# SALISBURY PARK NORTH PHASE 1

## TOWN OF PARKER SITE PLAN

NOVEMBER 22, 2024

**G-000**  
SITE PLAN SUBMITTAL  
Page 1 of 311

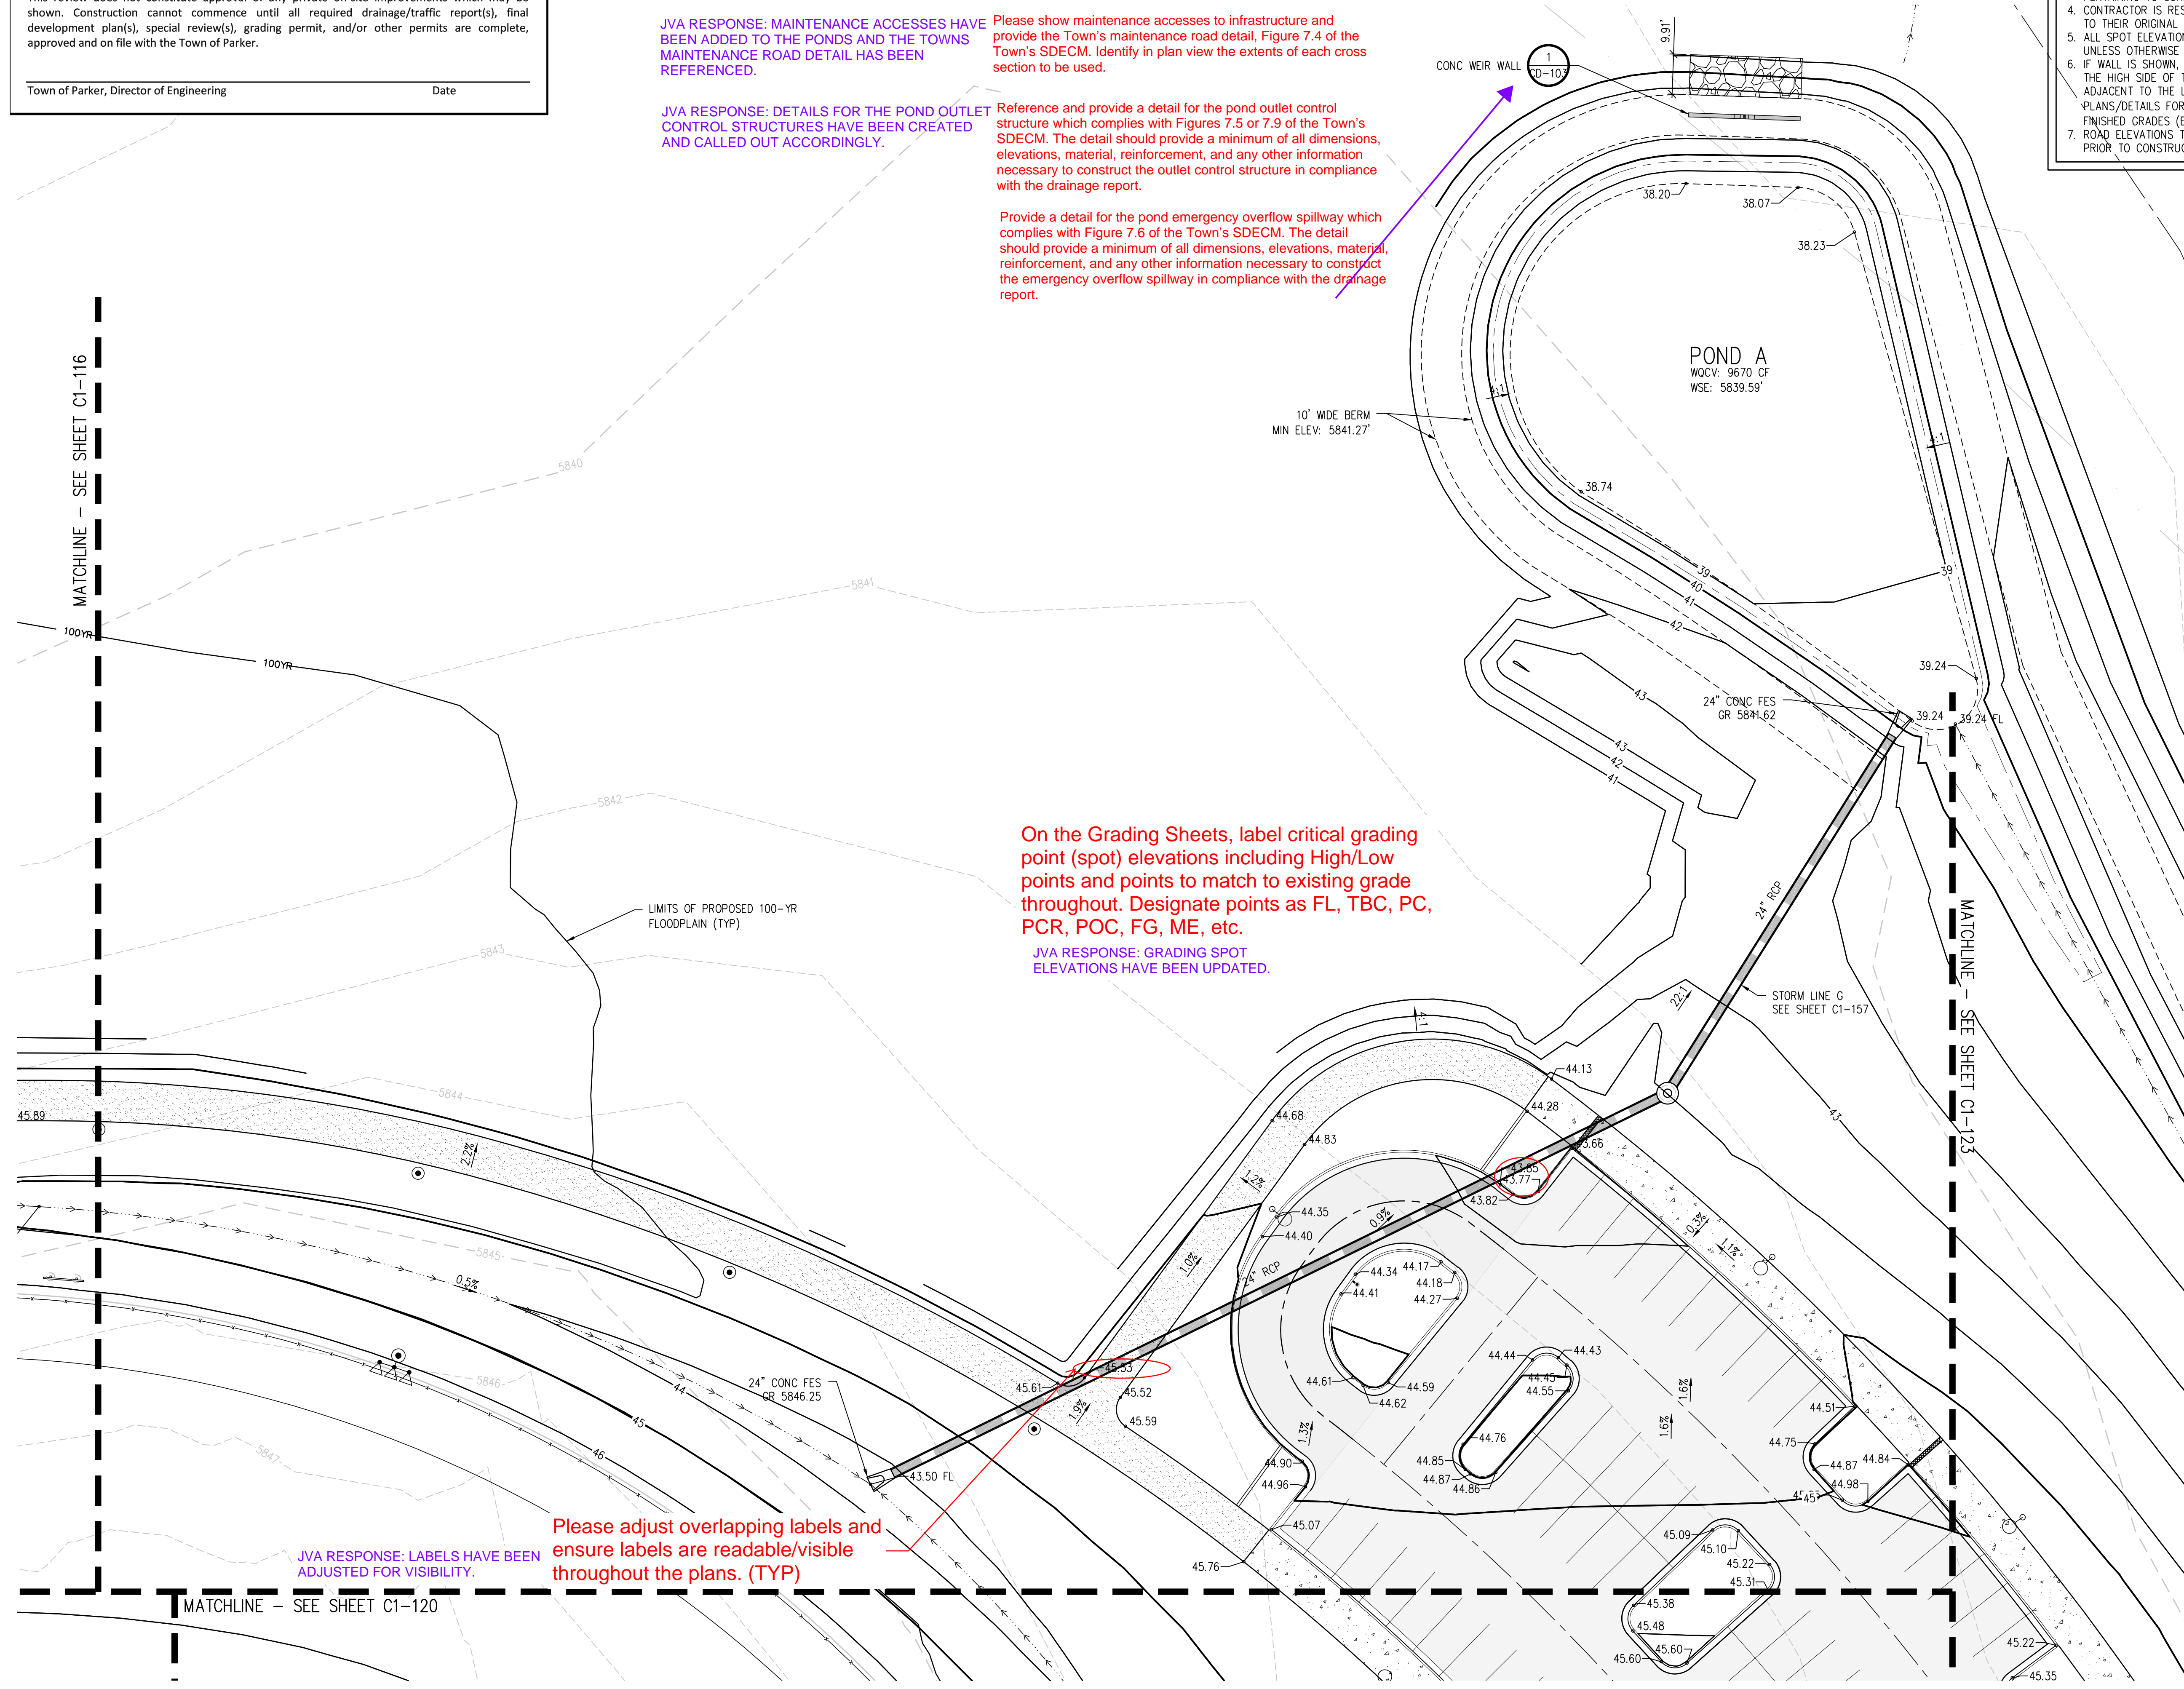
Please show maintenance accesses to infrastructure and provide the Town's maintenance road detail, Figure 7.4 of the Town's SDECM. Identify in plan view the extents of each cross section to be used.

Reference and provide a detail for the pond outlet control structure which complies with Figures 7.5 or 7.9 of the Town's SDECM. The detail should provide a minimum of all dimensions, elevations, material, reinforcement, and any other information necessary to construct the outlet control structure in compliance with the drainage report.

Provide a detail for the pond emergency overflow spillway which complies with Figure 7.6 of the Town's SDECM. The detail should provide a minimum of all dimensions, elevations, material, reinforcement, and any other information necessary to construct the emergency overflow spillway in compliance with the drainage report.

JVA RESPONSE: LABELS HAVE BEEN ADJUSTED FOR VISIBILITY.
